SUBJECT: TECHNICAL REVIEW OF HYDROLOGICAL STUDIES AND DATA
FOR IDAHO NATIONAL LABORATORY, IDAHO NUCLEAR
TECHNOLOGY AND ENGINEERING CENTER, TANK FARM
FACILITY (PROJECT NO. PROJ0735)

Technical Review of Hydrological
Studies and Data at the INL INTEC TFF

Technical Review of Hydrological Studies and Data for the Idaho National Laboratory, Idaho Nuclear Technology and Engineering Center, Tank Farm Facility

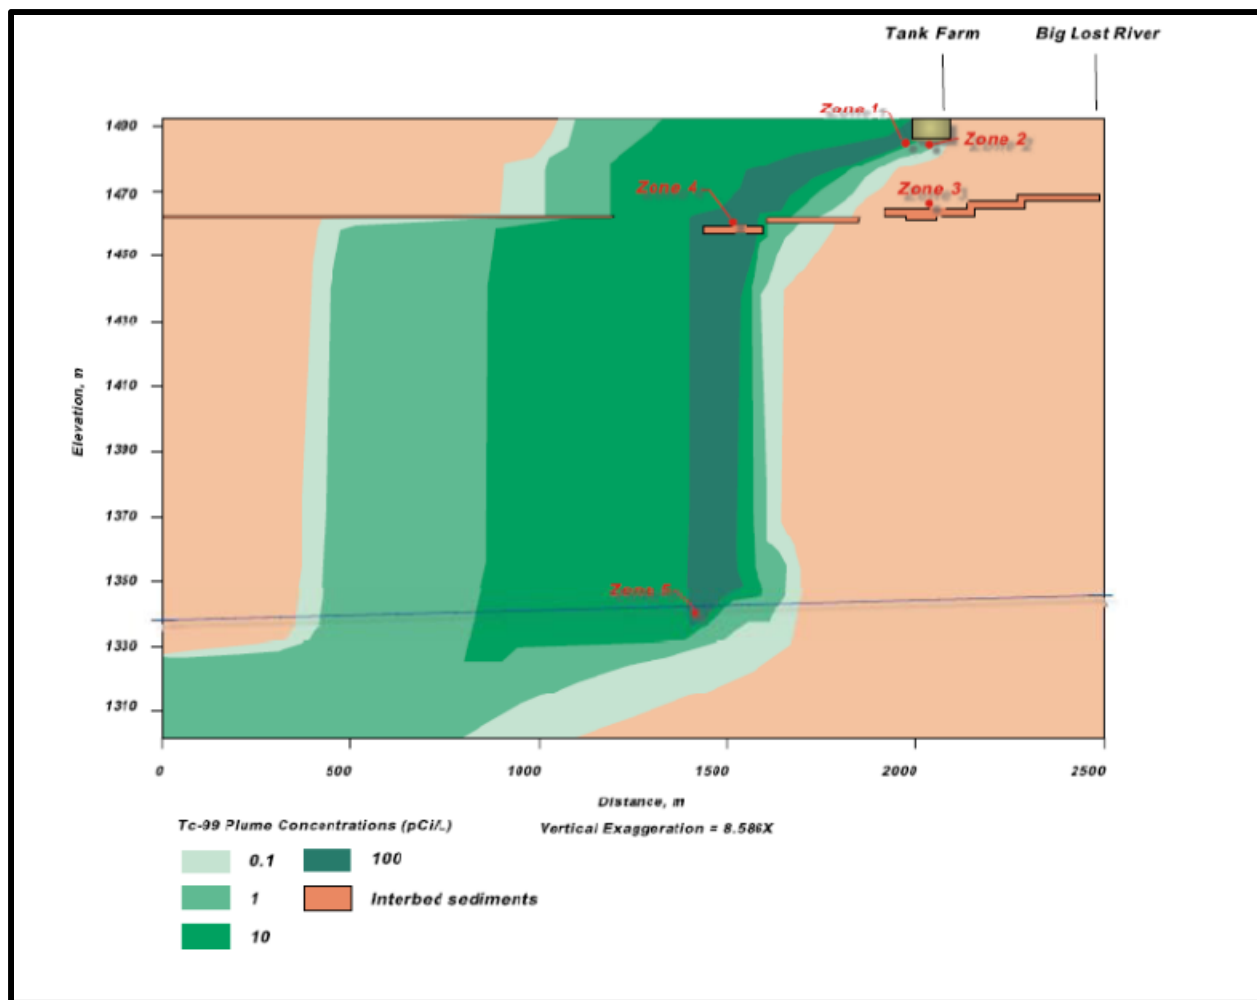
During the 2010 onsite observation, NRC staff was provided an opportunity to discuss groundwater monitoring issues identified during NRC staff's review of DOE's Performance Assessment (DOE, 2003) with DOE contractors working on related CERCLA projects. DOE contractor staff confirmed NRC staff's understanding of recent CERCLA monitoring results that indicate that only monitoring wells located very close to the Big Lost River, north the of the INTEC facility, show a water level response following rare occasions when Big Lost River flow occurs on site. DOE contractors indicated that Big Lost River flow is currently thought to have little impact on perched water further away from the river near INTEC facilities. The limited influence of the Big Lost River on perched water at the INTEC TFF based on current observations is contrary to conclusions drawn by DOE during development of its performance assessment models⁵. More recently, INL scientists have determined that anthropogenic sources of water to the INTEC subsurface and precipitation infiltration have a much larger effect

on perched water at the INTEC TFF. DOE's assumption that Big Lost River seepage was a source of perched water observed in the northern portion of the INTEC may have negatively impacted the calibration process, as well as led to overly optimistic assumptions regarding vadose zone performance.

DOE contractors also presented data on perched and Snake River Plain Aquifer groundwater sampling at INTEC. Based on review of this data, NRC staff concludes that releases from TFF waste transfer system piping are proximal to the INTEC TFF and that limited lateral movement in the vadose zone, primarily to the southeast of the facility, has been observed (e.g., NRC, 2008; NRC, 2009; NRC, 2012). There is also evidence of rapid, preferential flow through a complex network of fractures, as significant radioactivity associated with the TFF waste transfer system releases has also been observed to the north of the facility, up-gradient of the direction of saturated groundwater flow (see [DOE, 2004] for more information about TFF releases and contaminant plumes). Infiltration associated with melting of accumulated snow in the spring has also been implicated with rapid transport of constituents through the subsurface at INL.
